UNITED STATES
NUCLEAR REGULATORY COMMISSION
WASHINGTON, D.C. 20555-0001

SUBJECT: REVIEW OF RECORDS RELATING TO A DIFFERING
PROFESSIONAL VIEW

<u>NO.</u>	<u>DATE</u>	<u>DESCRIPTION/(PAGE COUNT)</u>
1.	5/23/01	Memorandum to J Dyer from R Landsman, Subject: Differing Professional View Concerning the Startup of the Dry Cask Storage Loading Campaign at Dresden (3 pages)

1981 Crane Girder Damage

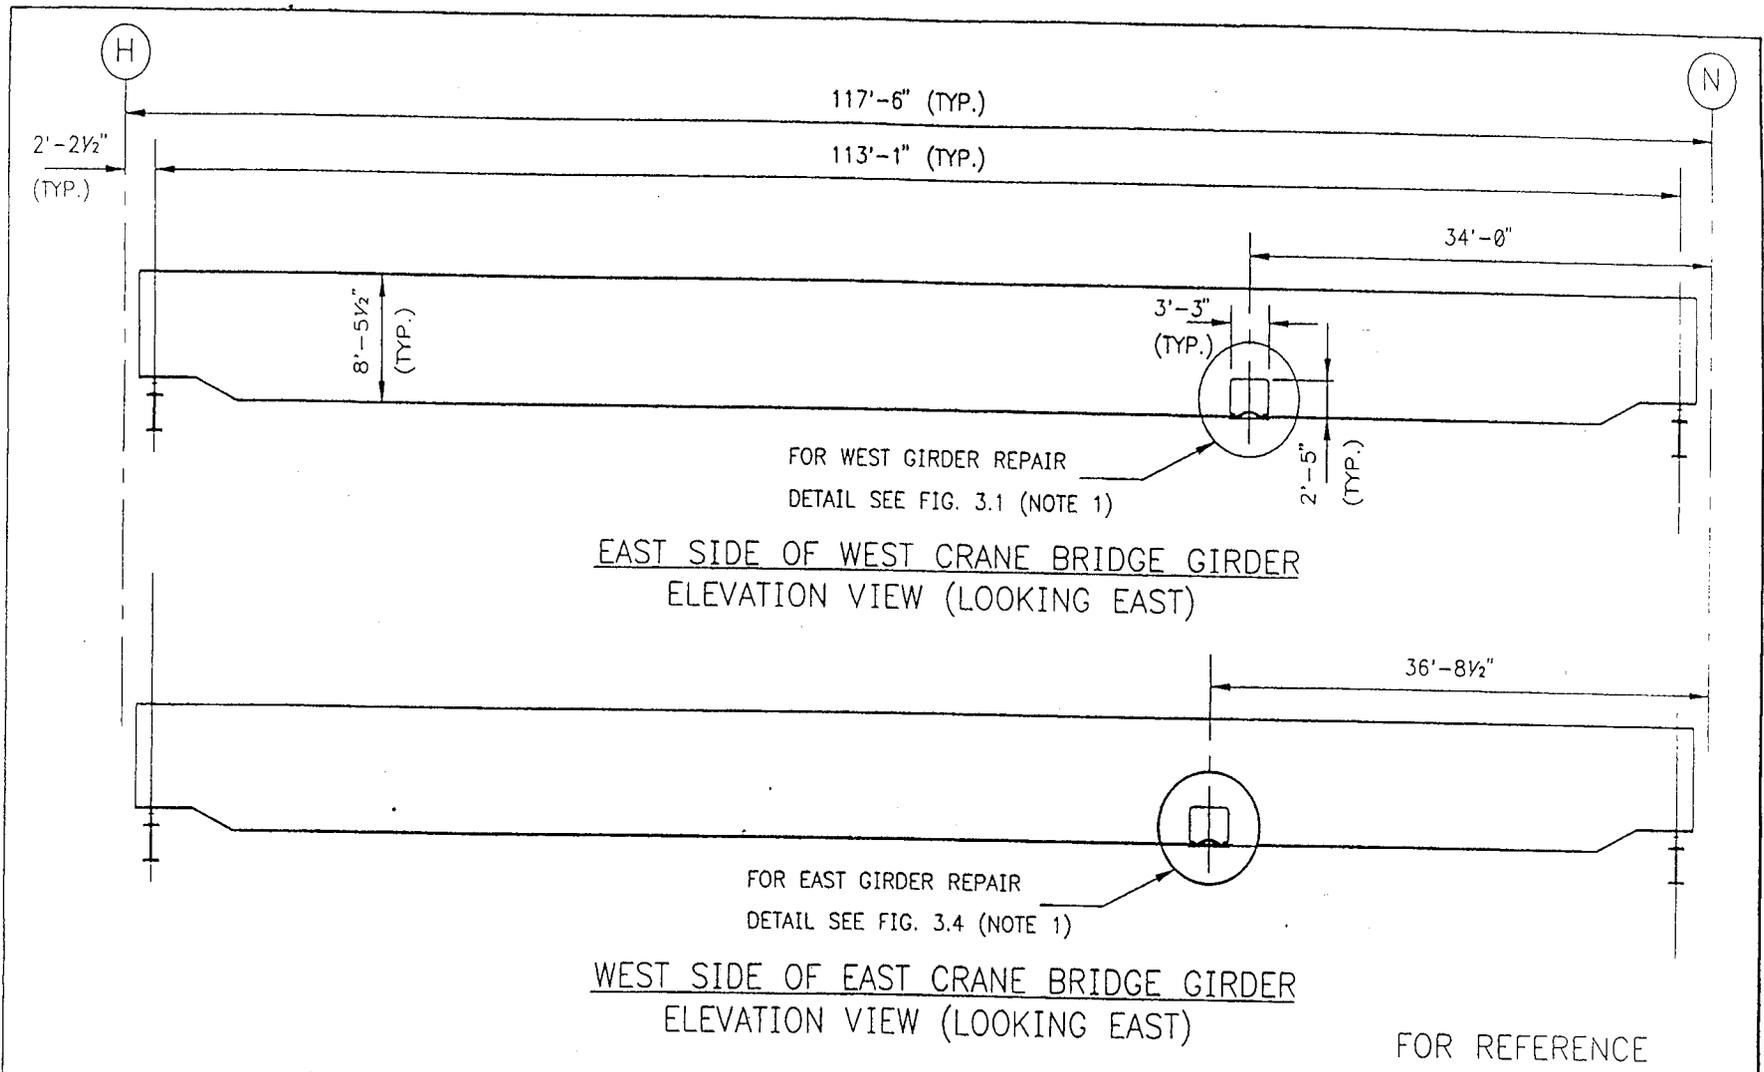
- Bottom of girders damaged by a 10 ton lifted load
- Damage affected 2' x 2'2" lower section of inside web and bent bottom flange on each girder (0.3% of total bridge girder surface area)

FIG. 3-2

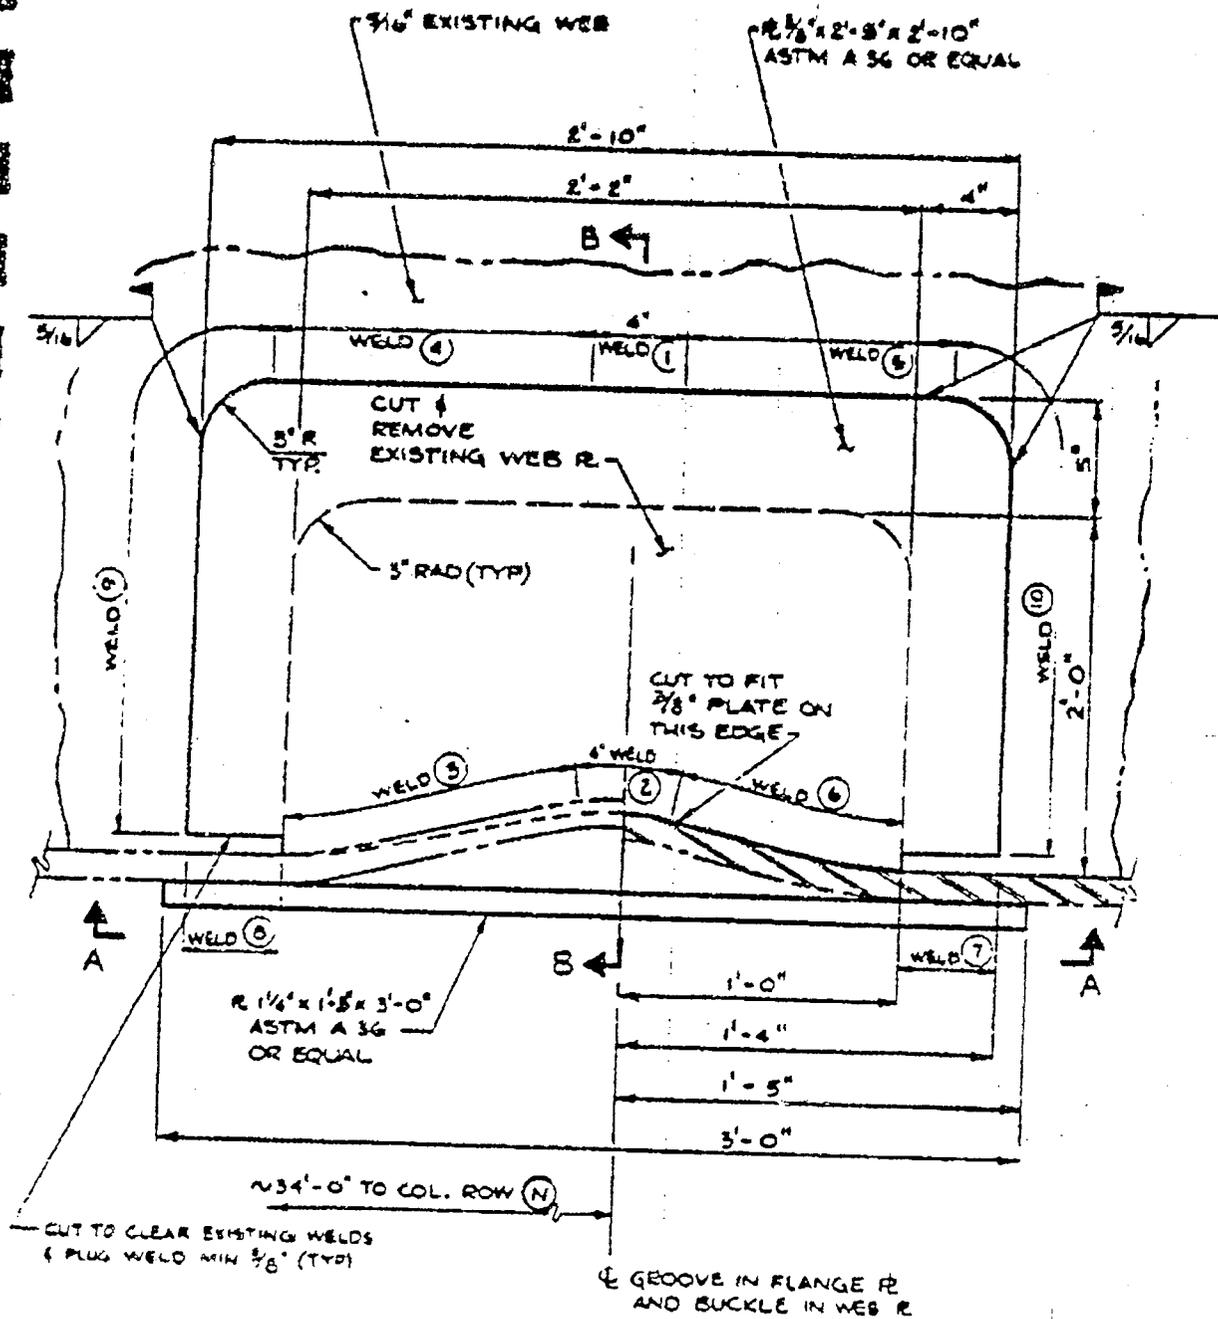
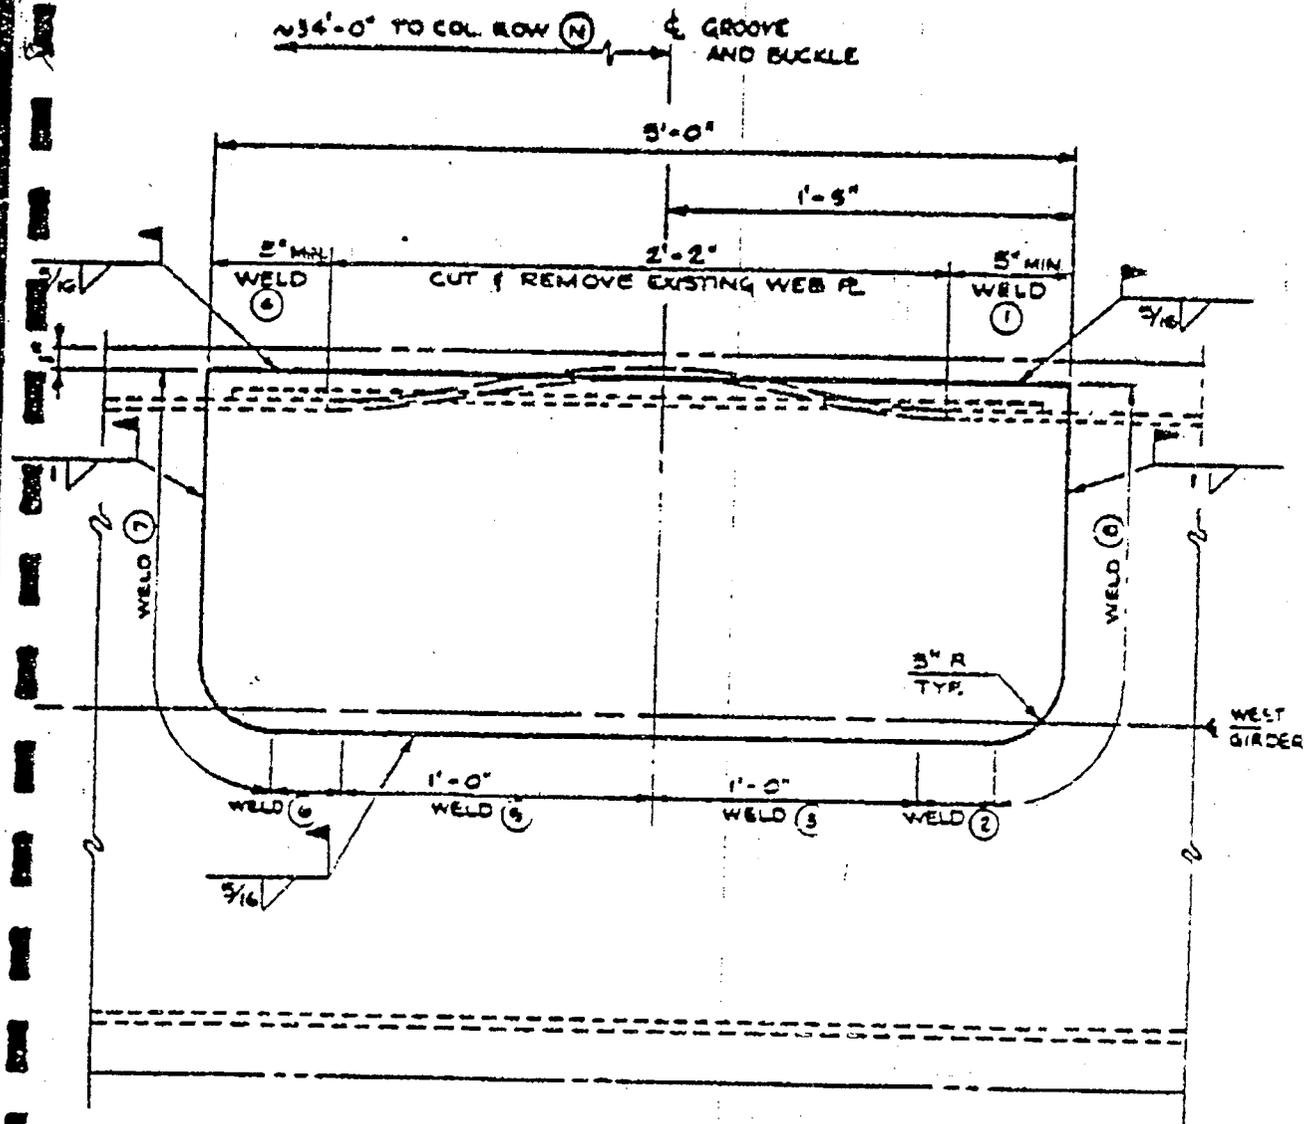
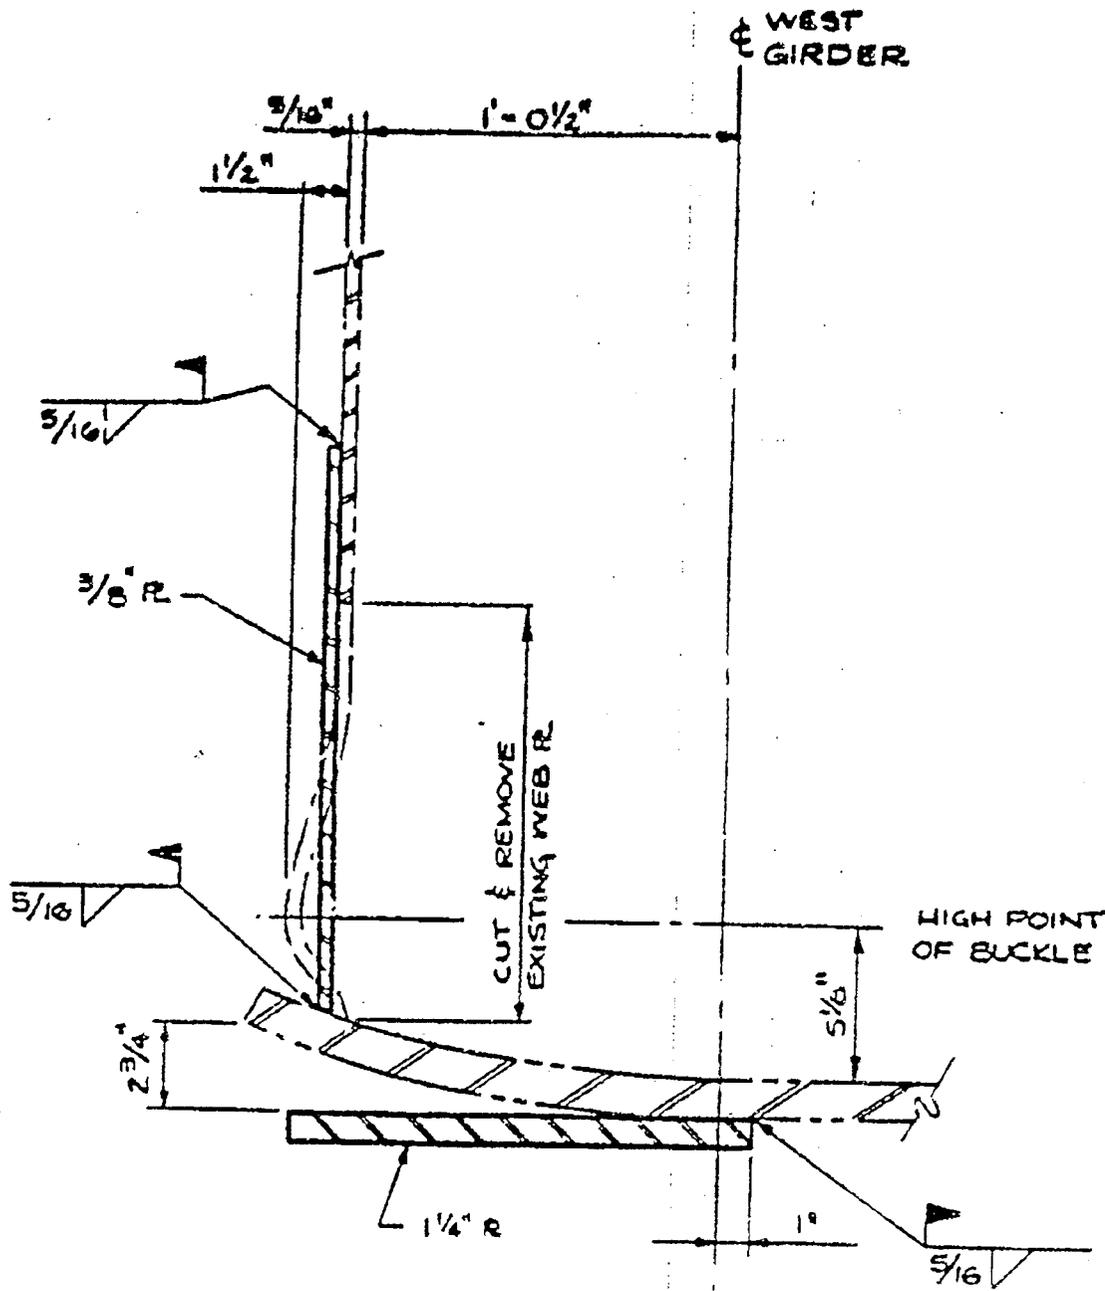
Based on the structural analysis performed, repairs to the west and east girders as presented in this report in Figure 3-1 through Figure 3-6 are recommended in order to restore their capacity to the original design value. Repairs to the crane bridge girders allow the structural calculations to be modified so that credit can be taken for the structural steel in the vicinity of the repaired areas. Based on this modified structural calculation, the repairs will restore the capacity of the crane bridge girders to the original design value.

The repairs and modifications to the existing crane girder shall be treated as safety related and shall be in accordance with AISC Specification (Reference 5.2). All welding for the repair shall be in accordance with AWS D1.1-1981 (Reference 5.7) and the Dresden Station welding procedures (Reference 5.8).
